AMENDMENT TO THE DRAWINGS

REMARKS

A. Drawing Rejections

Fig. 8

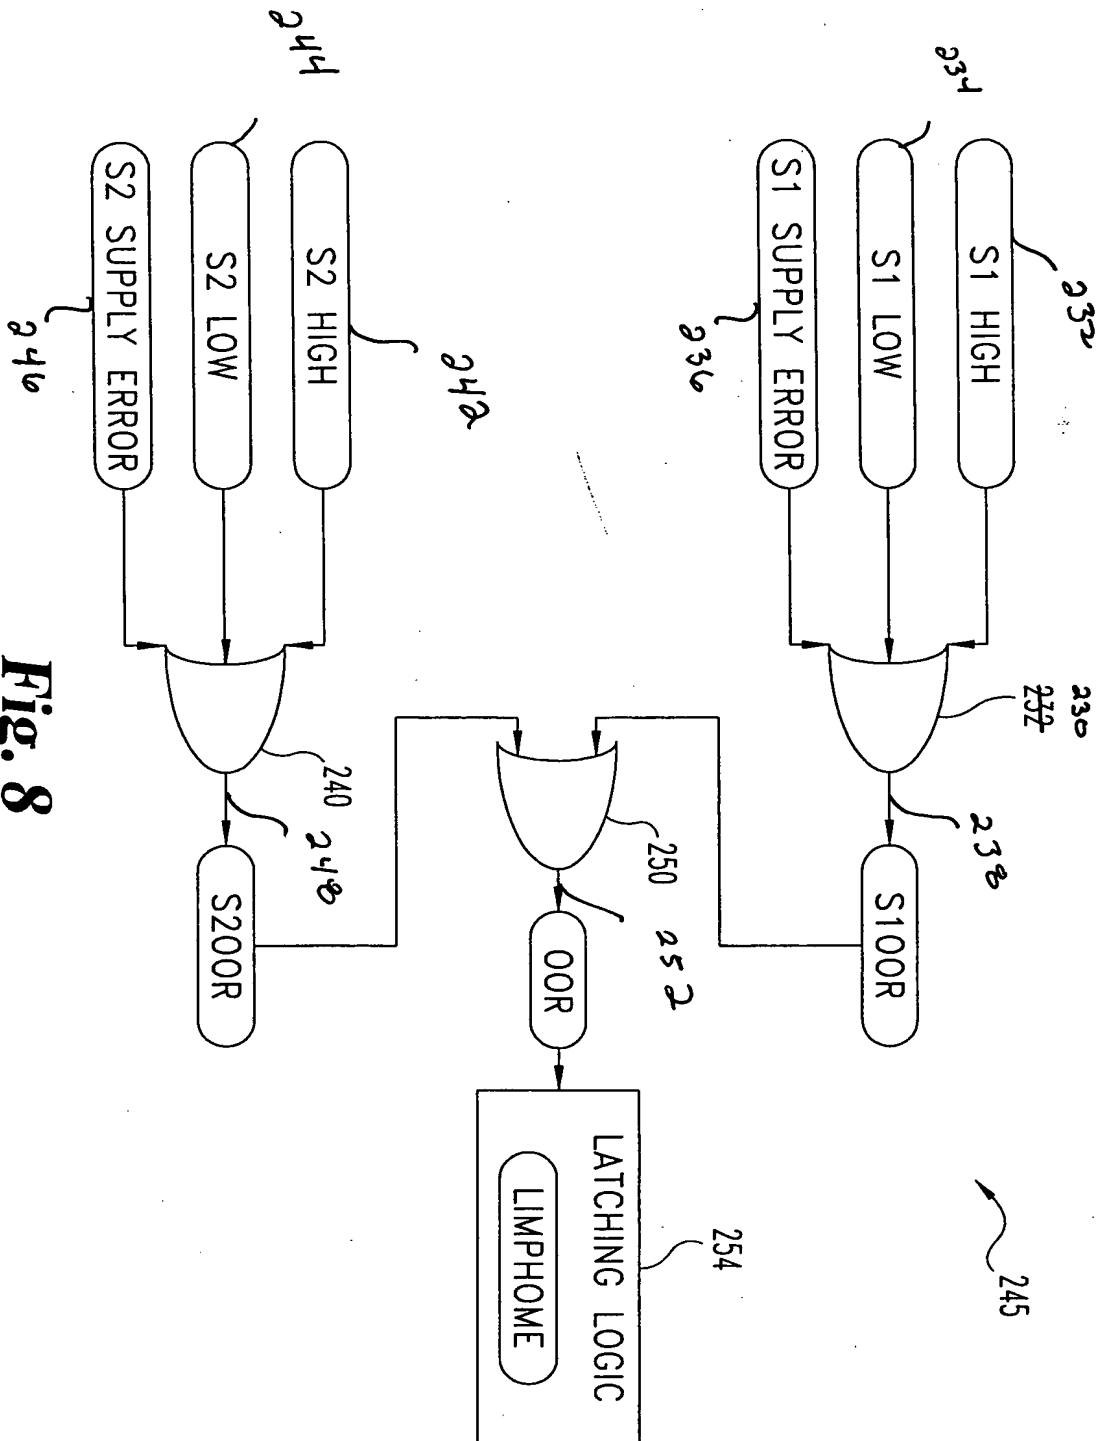
The Office Action rejected the drawings for failing to include reference numerals 230, 234, 236, 238, 242, 244, 246, 248, and 252. Furthermore, the drawings were objected to because in Fig. 8 reference numeral 232 should have been reference numeral 230 and in Fig. 11 the box labeled as S1 should have been labeled as S2. The Applicants have amended the drawings in light of the Office Action suggestions. The new drawings are included as Replacement Sheets in Appendix A and the changes are highlighted in the Annotated Marked-Up Copies in Appendix B.
